Solicitation #36C77623R0009 EHRM Infrastructure Upgrades Construction – St. Louis
Technical Questions and VA Response Tracking Sheet

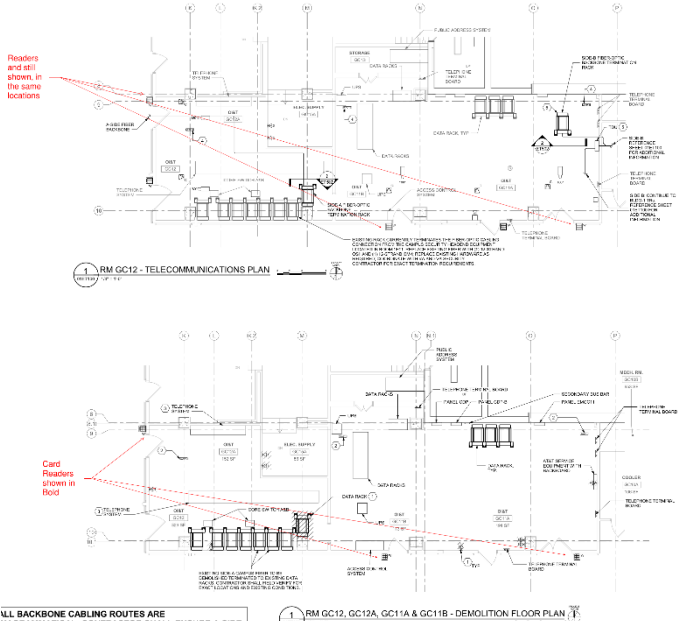
4.	3-10-23	3-14-23	Please define the requirements for unarmed guards during off duty hours. Is it the intent for the contractor to provide guards at all construction activities for the entire life of the project? What is the equipment requirement for recording guard rounds? Is this intended to be video surveillance documenting rounds or simply software tracking daily rounds?	Specification section 1.5 Construction Security Requirements Item C. Guards (1)(2)(3) was inadvertently inserted into the specifications and is NOT applicable.
